Our ref
DSA000011928

Date
10/06/2022

Proposal: Demolition of all existing buildings and structures and redevelopment of the existing car salvage and recycling facility to provide 80 No dwellings and a co-working hub, with vehicular access from Fontwell Avenue, provision of public open space, landscaping, and other associated works. This application is a Departure from the Development Plan is in CIL Zone 3 and is CIL Liable as new dwellings.

Site: AL/49/22/PL: - Sussex Recovery Company, Fontwell Avenue, Eastergate PO20 3RU.

ARUN DISTRICT COUNCIL AL49/22/PL

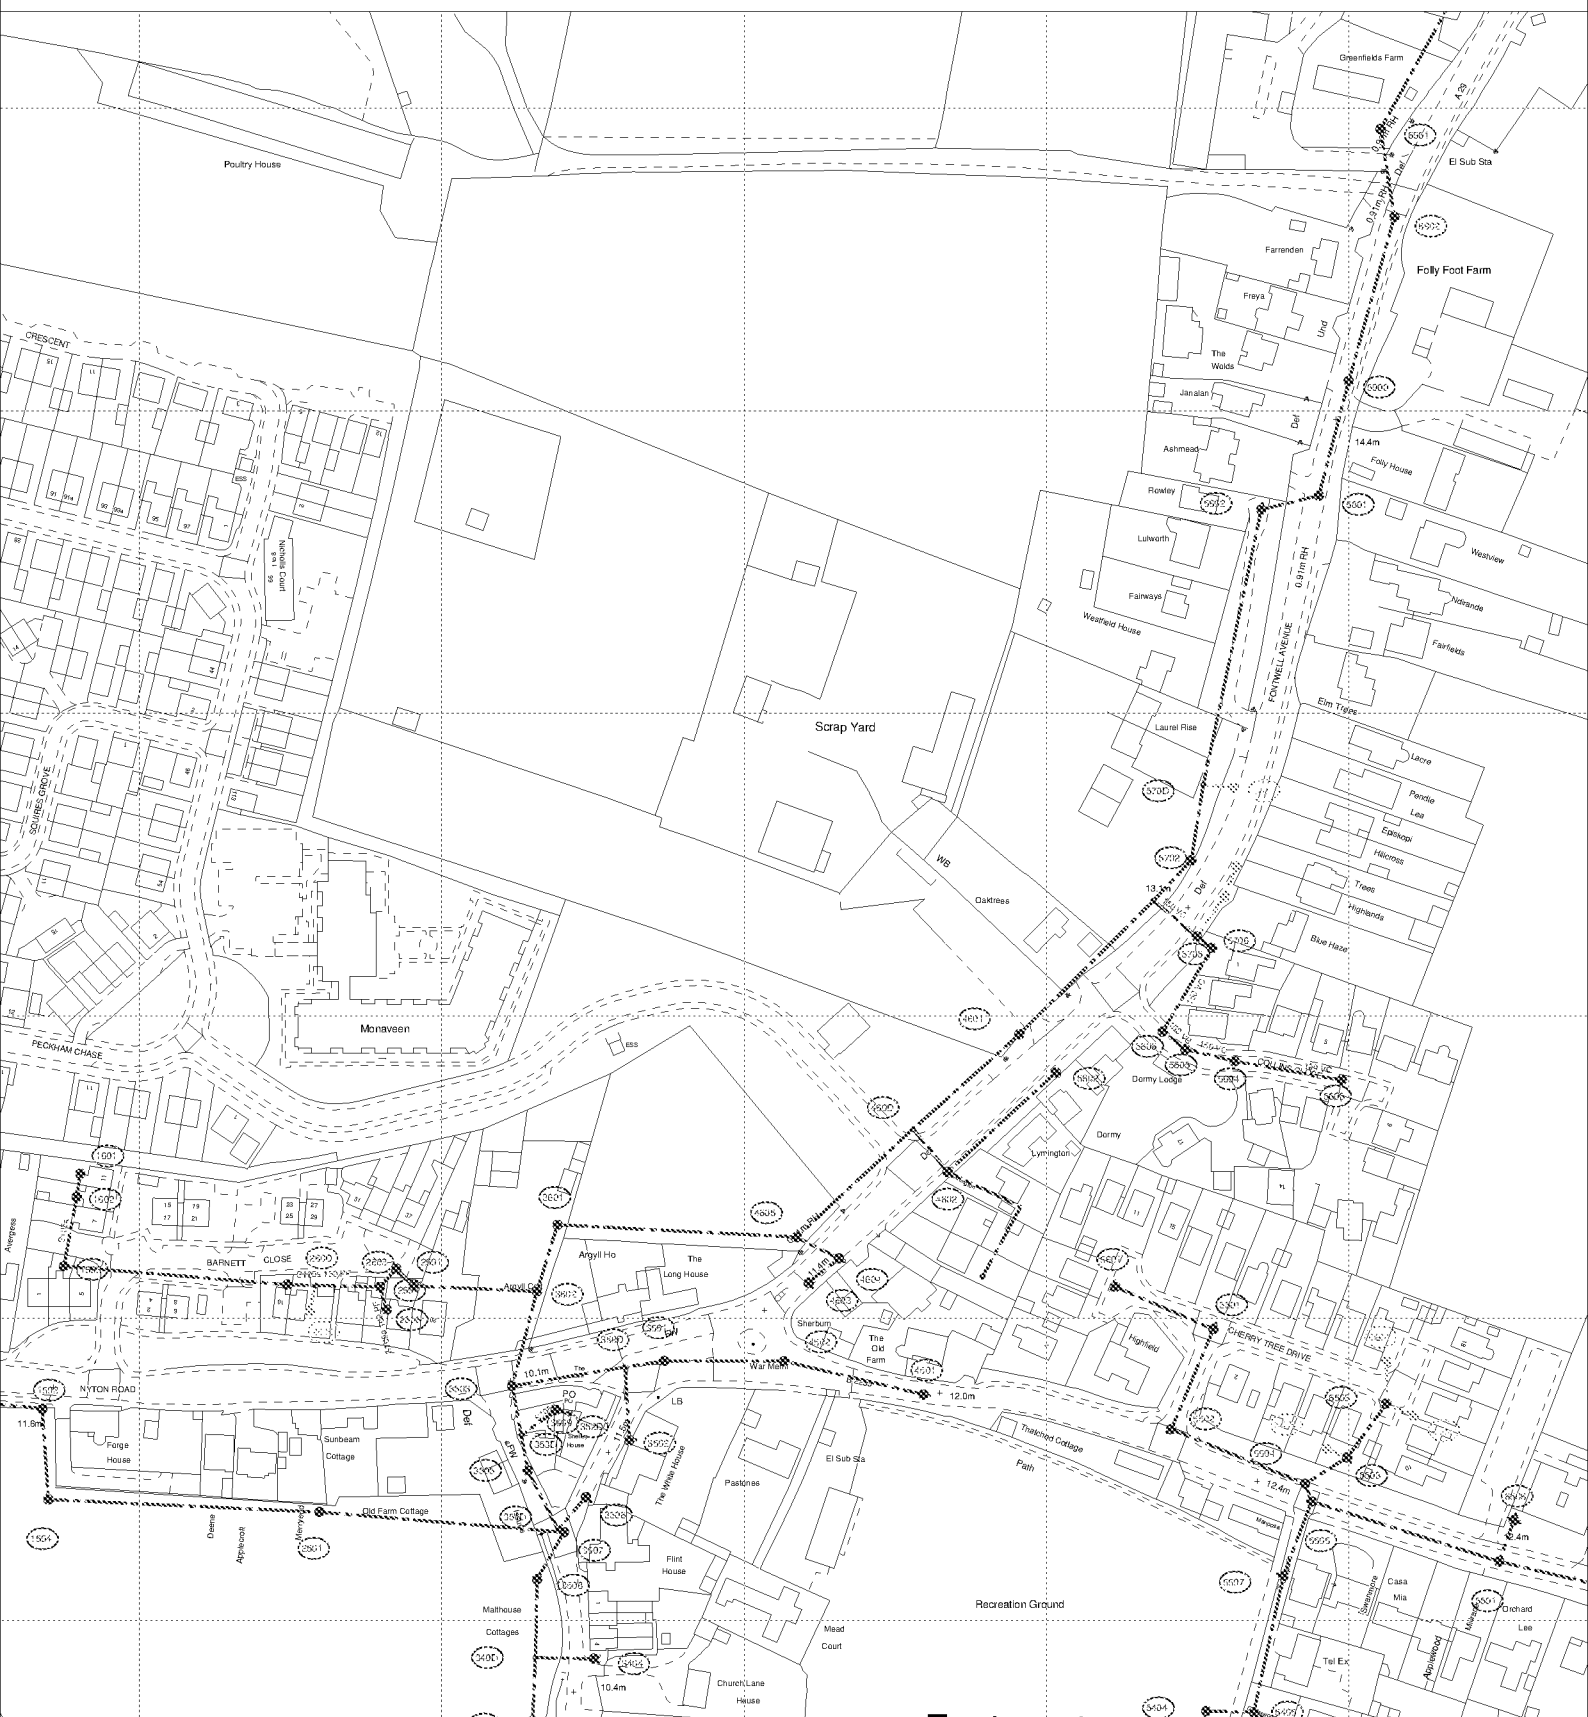
Please see the attached extract from Southern Water records showing the approximate position of our existing public foul sewer asset within the development site. The exact position of the public assets must be determined on site by the applicant in consultation with Southern Water before the layout of the proposed development is finalised.

- The 225 mm public foul sewer requires a clearance of 3 metres on either side of the gravity sewer to protect it from construction works and to allow for future access for maintenance.
- No new development or tree planting should be carried out within 3 metres of the external edge of the public gravity sewer without consent from Southern Water.
- No new soakaway, swales, ponds, watercourses or any other surface water retaining or conveying features should be located within 5 metres of a public sewer.
- All existing infrastructure should be protected during the course of construction works.
